**UNITED STATES
NUCLEAR REGULATORY COMMISSION**
REGION IV
1600 E LAMAR BLVD
ARLINGTON, TX 76011-4511

**SUBJECT: ARKANSAS NUCLEAR ONE – NRC INSPECTION REPORT 05000313/2014009
AND 05000368/2014009; PRELIMINARY YELLOW FINDING**

IR 05000313/2014009; 05000368/2014009; 02/10/2014 – 08/01/2014; Arkansas Nuclear One; Adverse Weather Protection.

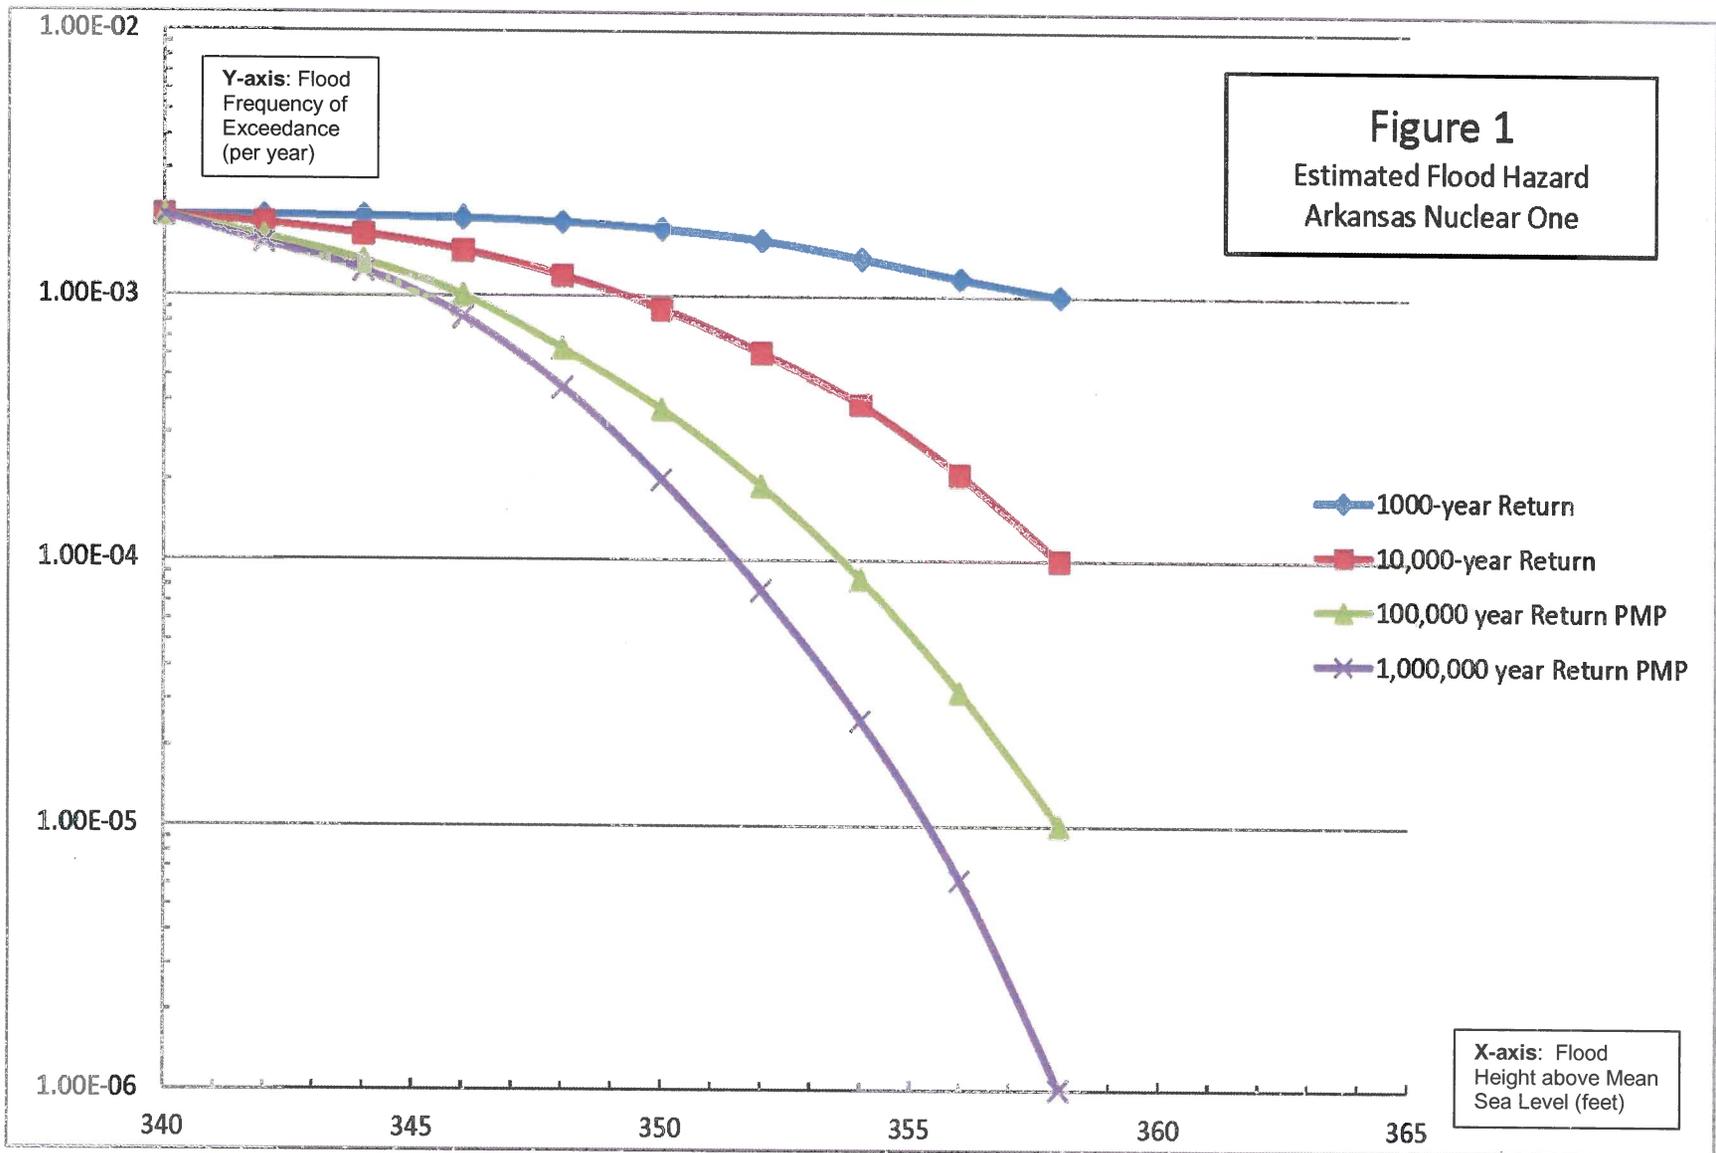
The credibility of the extrapolated flood frequency results for the range of interest with the available data and methodology is highly limited, given the current state-of-practice in probabilistic flood hazard assessment. The licensee’s curve (see Figure 5) is based on an extrapolation of 75 years of data. The curve is based, in

part, on a revised probable maximum flood that was 40 percent lower than the one developed by the U. S. Army Corps of Engineers and presented in the safety analysis report. Existing guidance on the application of the specific approach used by the licensee, i.e., the U.S. Department of Interior Geological Survey Bulletin 17B, "Guidelines for Determining Flood Flow Frequency," indicated the subject approach was not intended to provide sufficient confidence beyond the 100-year to 500-year return period range. In addition, the NRC risk analysts noted that the licensee's curve did not converge with the 500-year flood, despite the fact that the 500-year flood occurred once during the 75 years considered.

The licensee's flood hazard curve suggests that a flood of the Arkansas River bringing the level of Lake Dardanelle to elevation 340 feet MSL represented approximately the 7700-year return flood (1.3×10^{-4} /year). Given that a storm in May 1943 provided a peak floodwater flow equivalent to an elevation of about 342 feet MSL, the NRC risk analysts performed a binomial test on the data. The NRC risk analysts determined that there was less than a 1 percent probability that there would be one or more occurrences of a flood to elevation 340 feet MSL in 75 years, if such a flood were actually the 7700-year return flood. Therefore, the NRC risk analysts rejected the null hypothesis that the probability of exceedance was 1.3×10^{-4} /year. At a significance level of $\alpha = 0.05$, the NRC risk analysts rejected the null hypothesis that the probability of exceedance was $\leq x$ for all $x \leq 0.000685$ (1460-year return flood). Using the same techniques, the NRC risk analysts determined that there was a 14 percent probability that there would be one or more occurrences of a 340 foot MSL elevation flood in 75 years, if this flood was the 500-year flood as indicated by the U.S. Army Corps of Engineers. Therefore, the Corps' original hypothesis that the 500-year flood was 340 feet MSL could not be rejected.

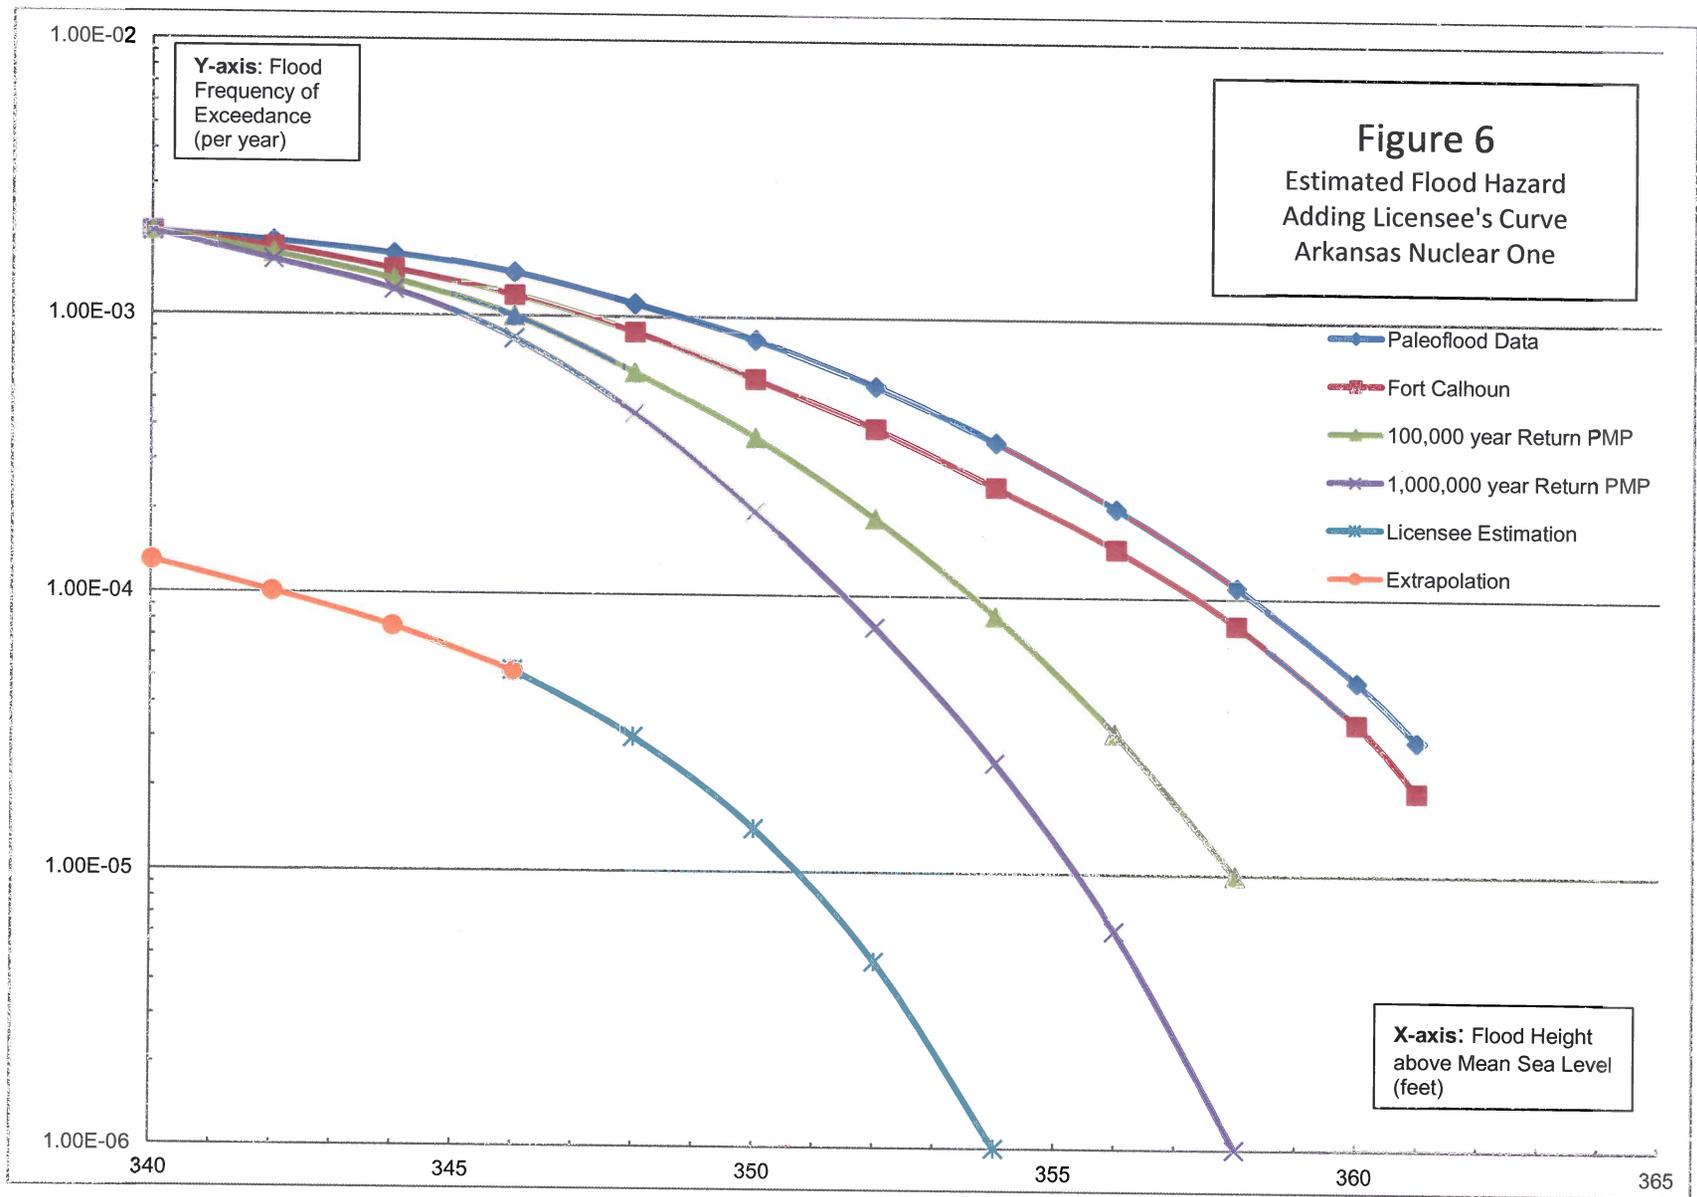
As shown in Figure 6, the licensee's partial development of its flood hazard curve indicates that the mean frequency of exceedance for a flood at site elevation 354 feet MSL was very close to 1×10^{-6} /year. This includes five orders of magnitude between the lower and upper 95th confidence limits. The NRC risk analysts also identified the following issues with the licensee's curve development:

1. The licensee's documentation clearly indicated that the extrapolated probable maximum flood curve was an estimate.
2. The probable maximum flood used in the frequency estimation is 40 percent lower than that provided by the U.S. Army Corps of Engineers and documented in the safety analysis report. This appears to be based on a draft licensee response to the NRC-required flooding re-evaluation per 50.54(f) that indicates the current licensing basis is conservative.
3. In lieu of U.S. Army Corps of Engineers data, the licensee used an assumption that the lake bottom was at the minimum channel depth throughout. The licensee considers this to be a conservative assumption because the channel is maintained deeper than the minimum channel depth; however, the NRC risk analysts noted that the channel is the lowest point in the lake and is a very small portion of the area of a lake.

4. There are no standard techniques or consensus methods to extrapolate flood frequencies into the ranges relevant to this risk evaluation. Most of the literature available on extrapolating flood frequencies is not intended to provide high confidence beyond the available historical record (typically, 100 years or less).
5. Finally, in graphing the licensee's contractor data, it does not converge with the 500-year flood data from the U.S. Army Corps of Engineers. Of note, the 500-year flood was one of the six significant floods that occurred in the 75 years of data available. The licensee's curve suggests that this was approximately the 7700-year flood.
